Project # 25036 (MKM), 2509-276 (Hafer) – EVPL Red Bank Library
New Construction / 120 S. Red Bank Road, Evansville, IN 47712

ADDENDUM No. 2

June 24, 2026

DRAWING CONTENTS:
LOWER ROOF FRAMING
PLAN

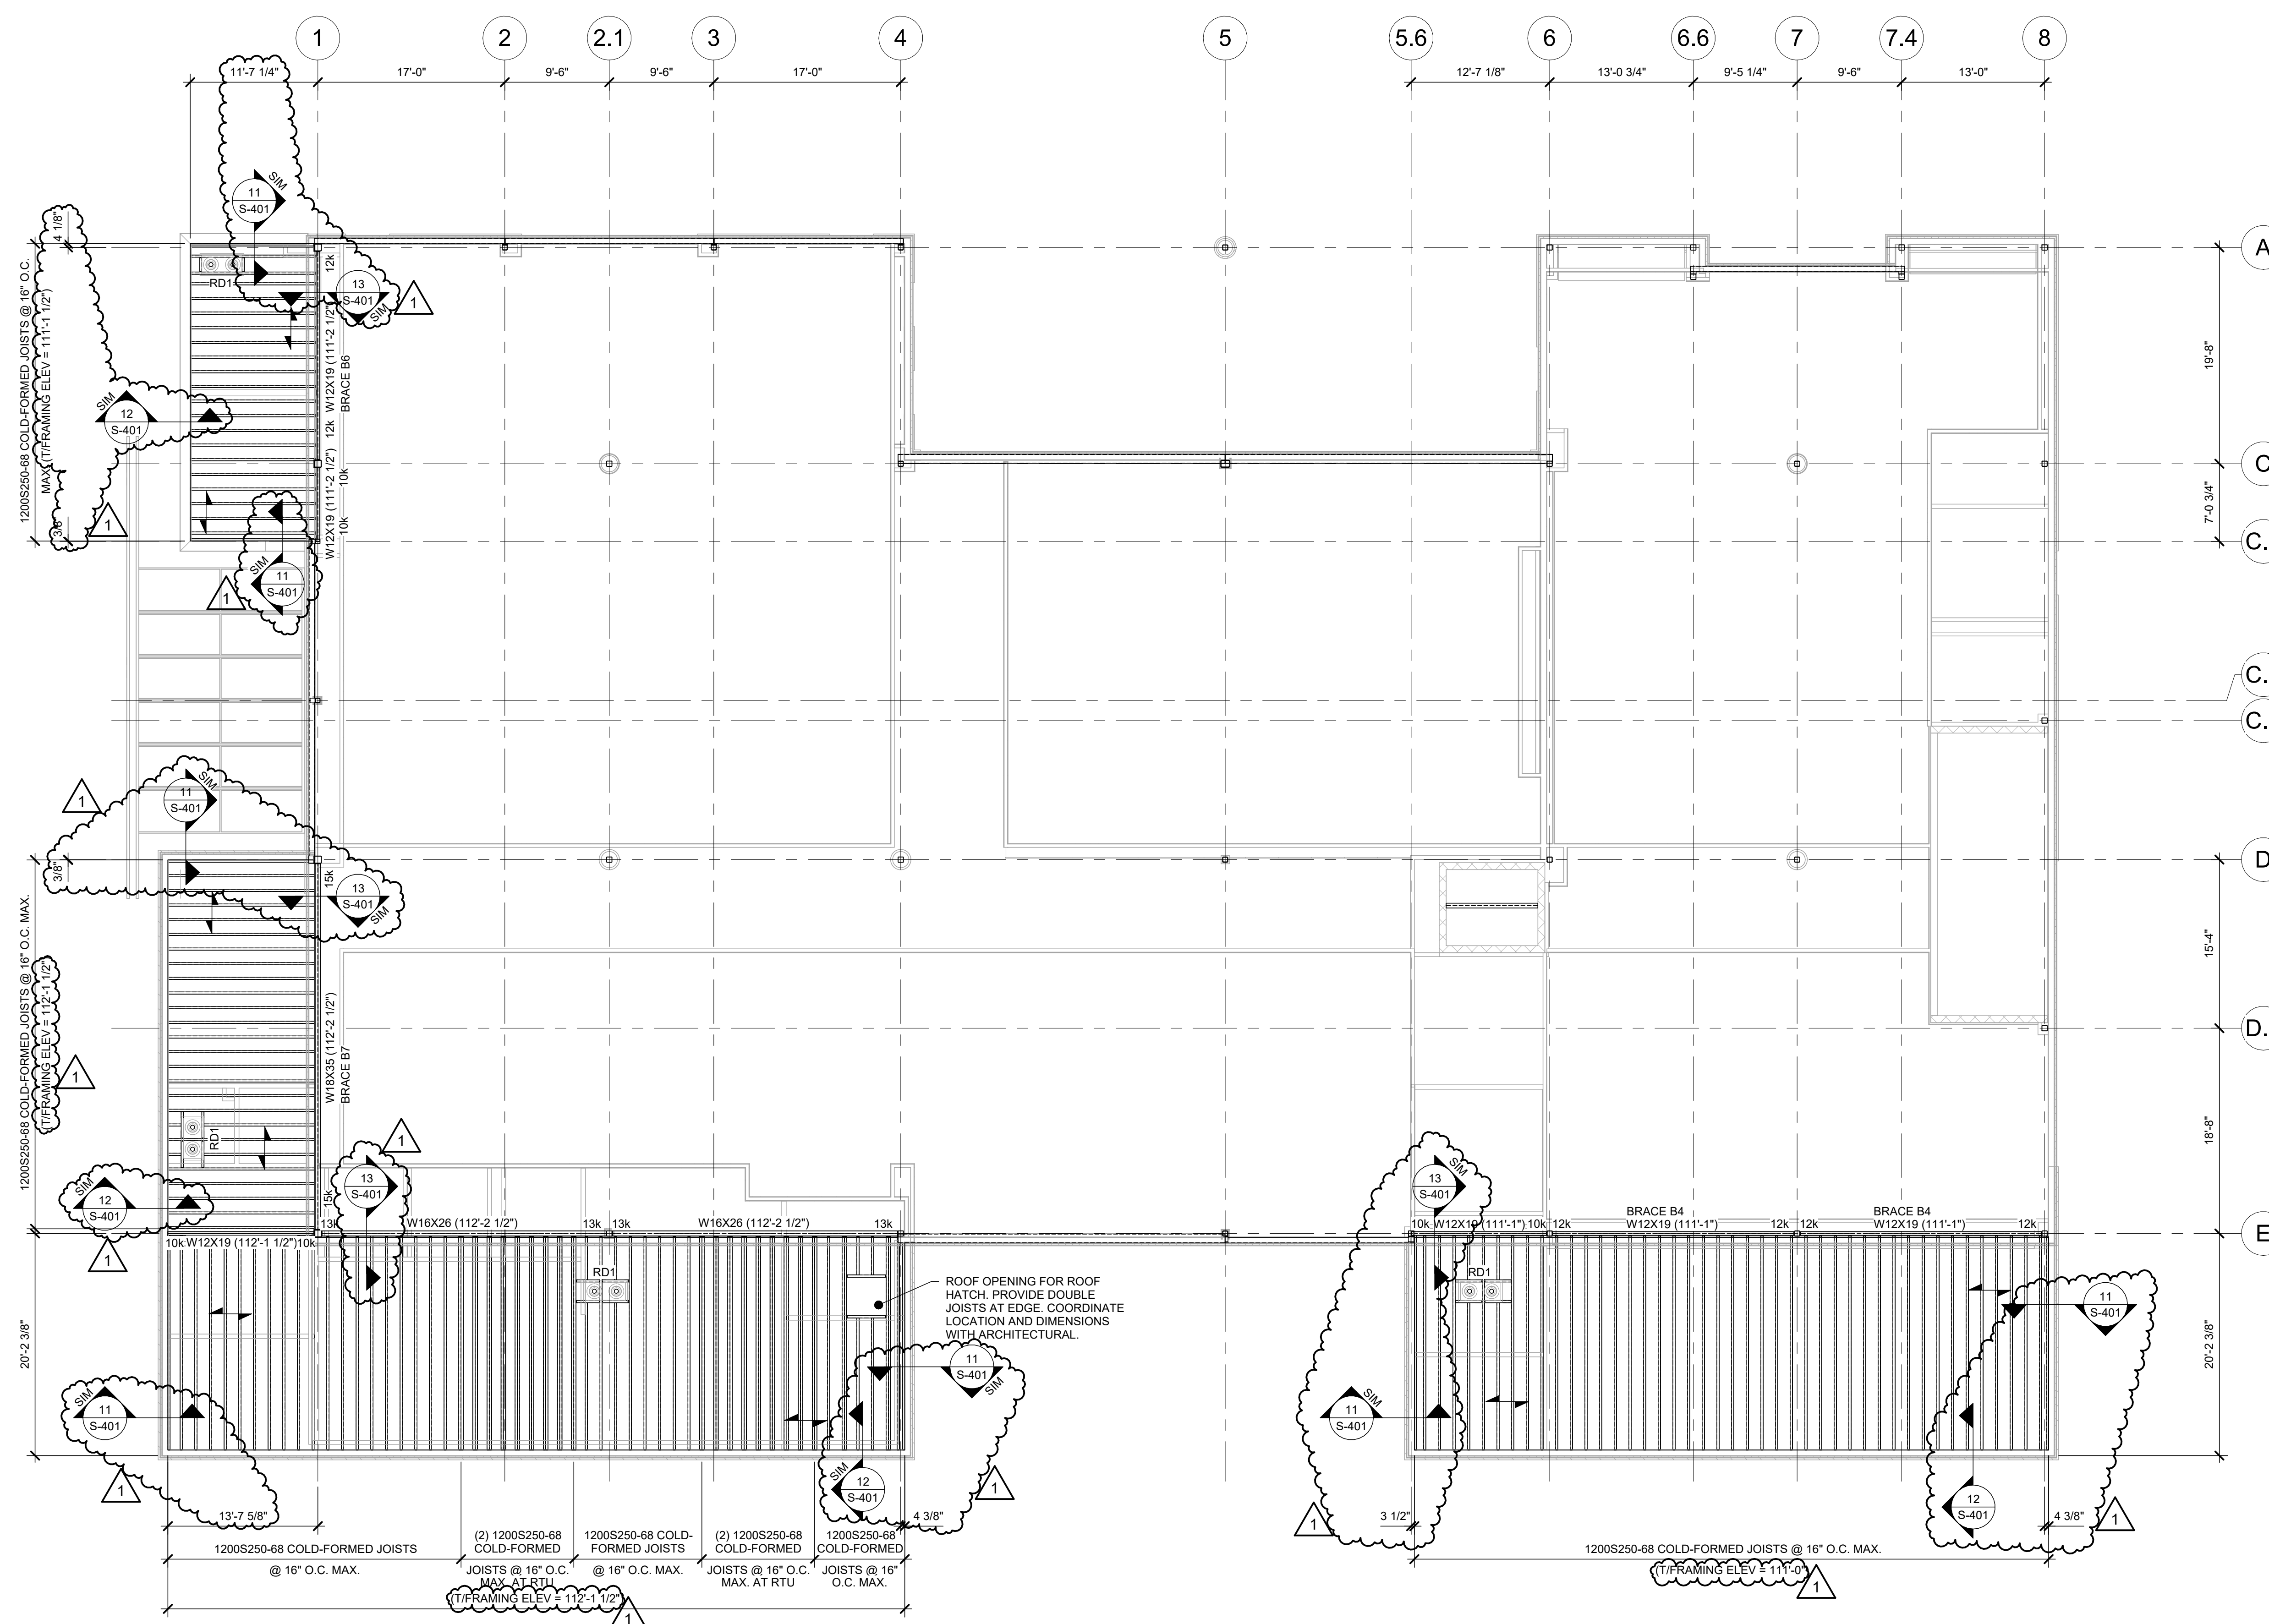
e. **Sheet S-103 – LOWER ROOF FRAMING PLAN**

- i. Clarification: Revised Framing Plan Note #6
- ii. Addition: Added Section cuts 11/S-401, 12/S-401 and 13/S-401
- iii. Addition: Added Top of Framing elevations to plan.
- iv. Clarification: Revised dimensions indicated.

SET DESCRIPTION:
CONSTRUCTION DOCUMENTS
DRAWING CONTENTS:
UPPER ROOF FRAMING
PLAN

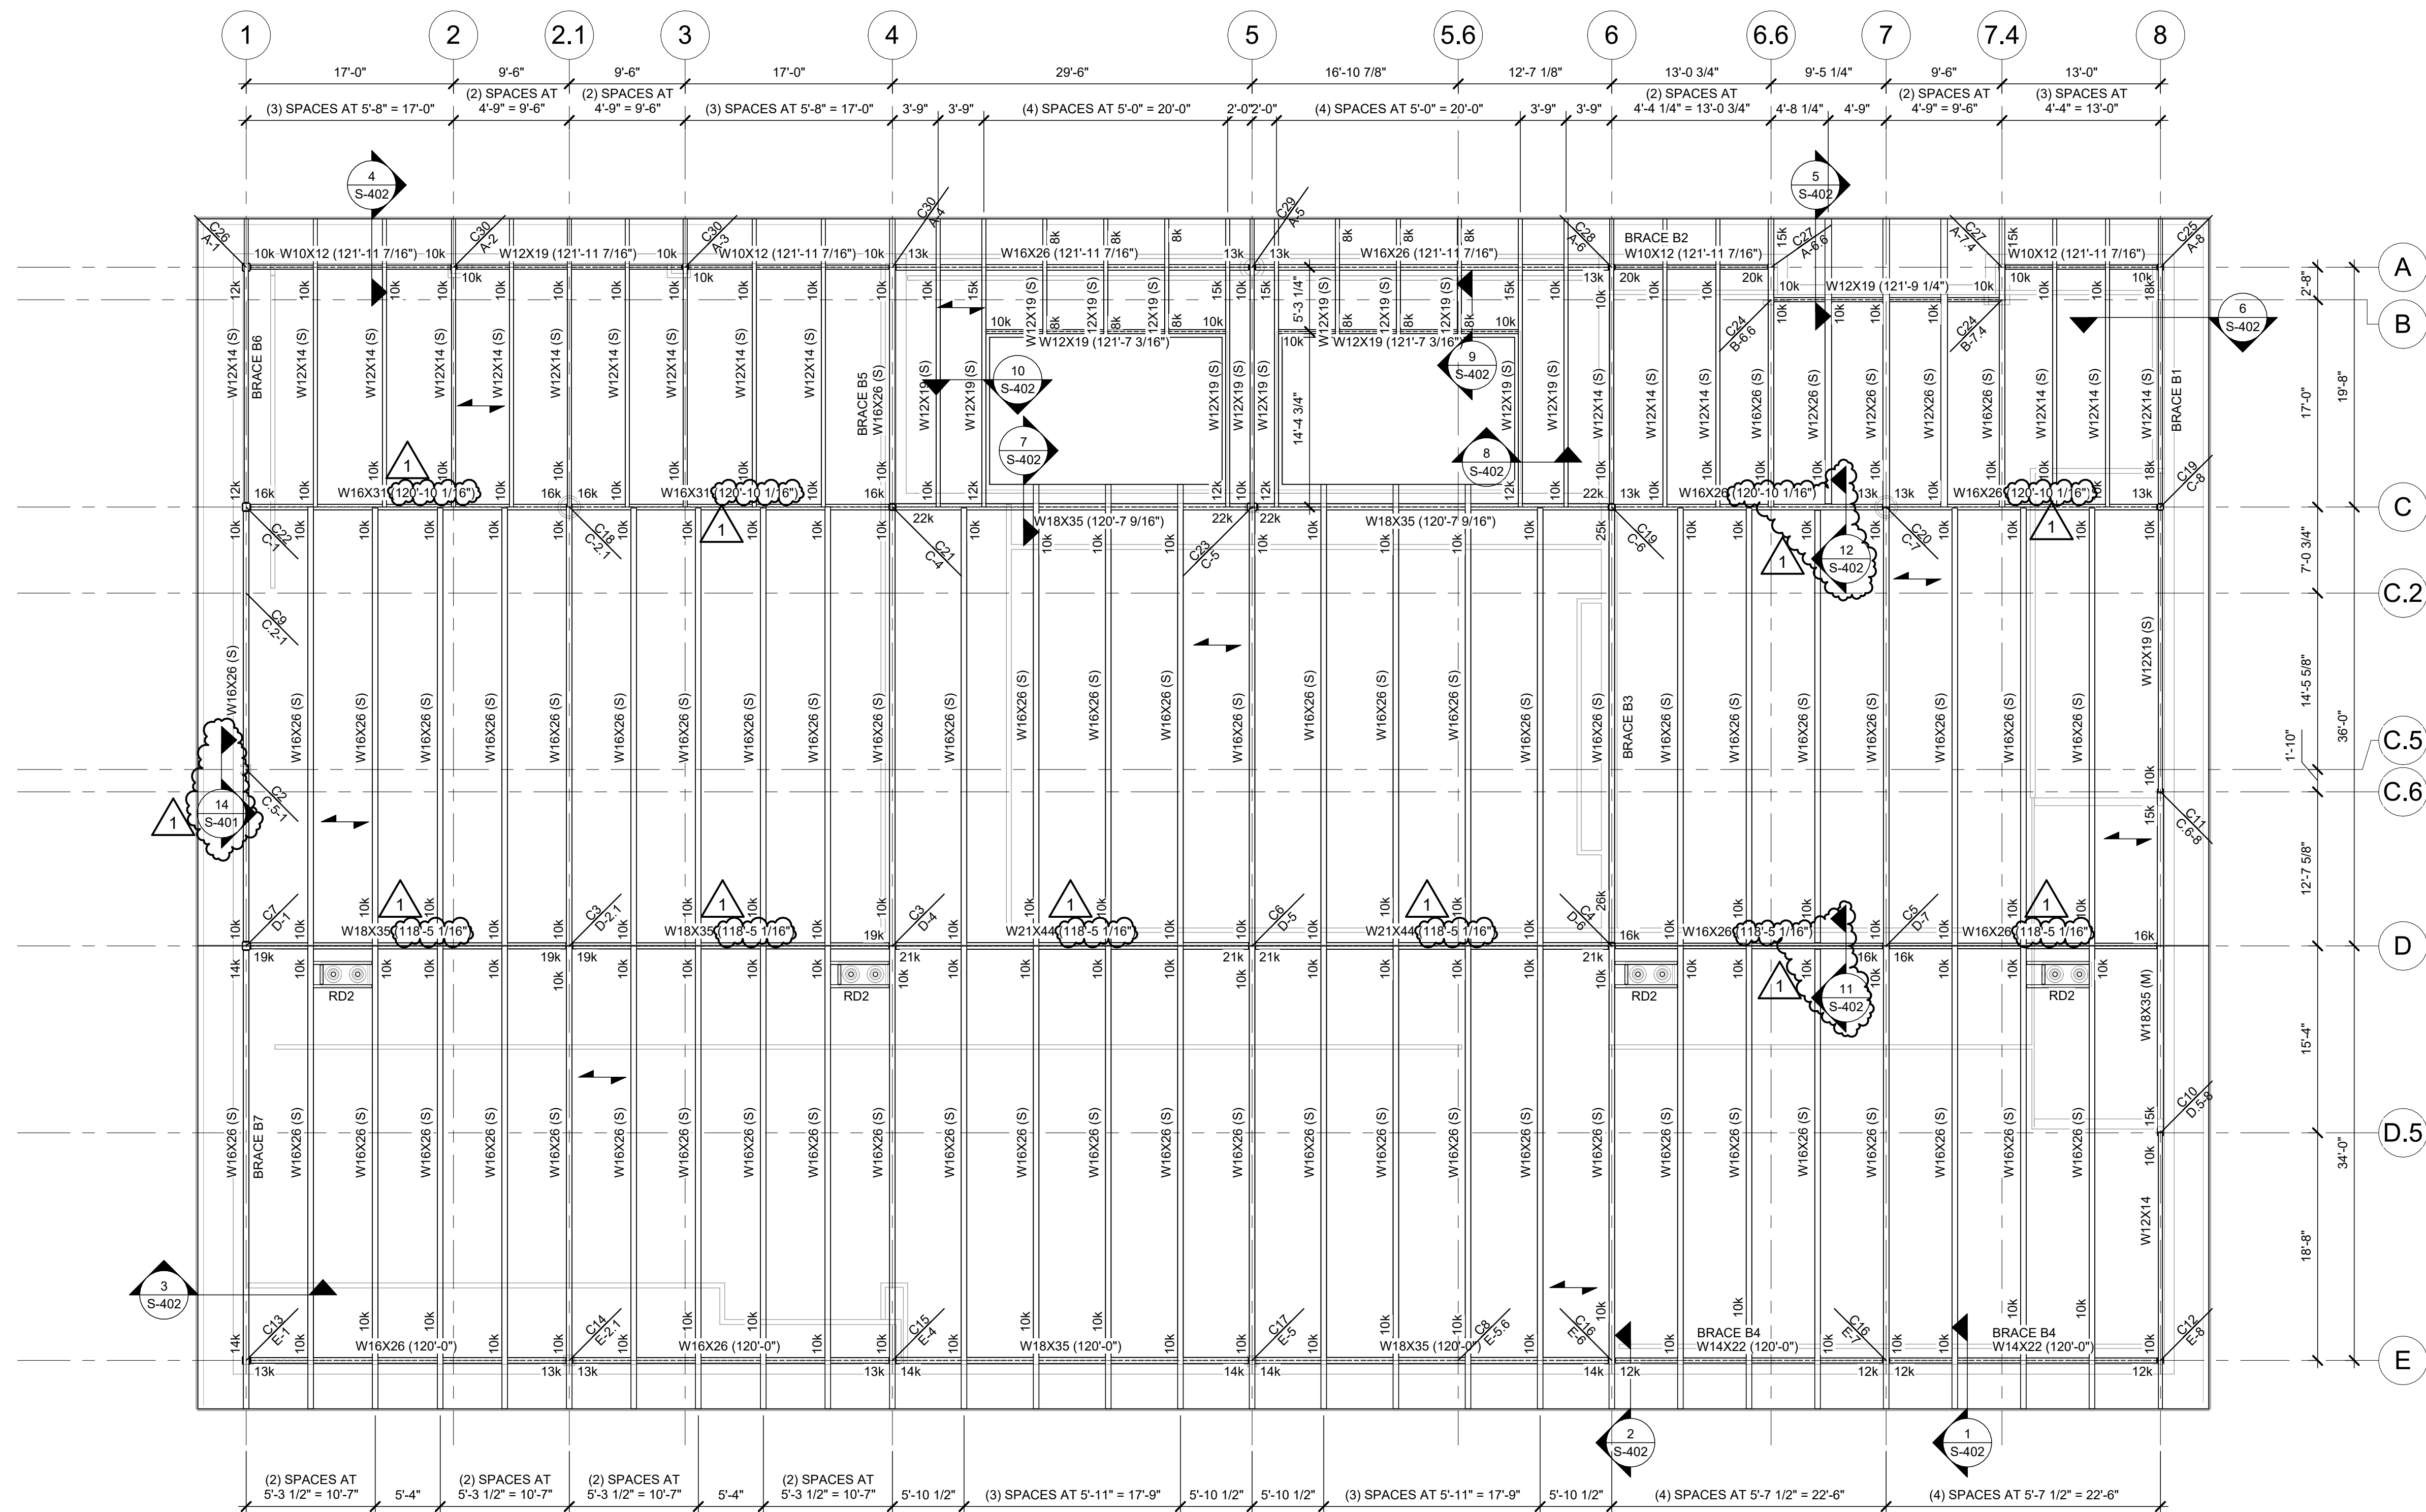
- f. **Sheet S-104 – UPPER ROOF FRAMING PLAN**
 - i. Addition: Added Framing Plan Note #14
 - ii. Clarification: Revised Top of Beam elevations indicated.

- iii. Addition: Added Section 14/S-401 to show top of column condition at wind columns.
 - iv. Addition: Added Sections 11/S-402 and 12/S-402 along grid lines D and C to clarify top of beam elevations.
